# ADA Curb Ramp New Construction Inspection Form (Perpendicular)

Nw 291 ave

23885.56

Nw fair st

## PERPENDICULAR RAMP (PR)

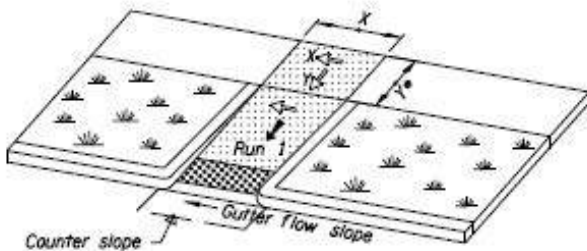
RR1 icrr turn space less than 4'™ clear width
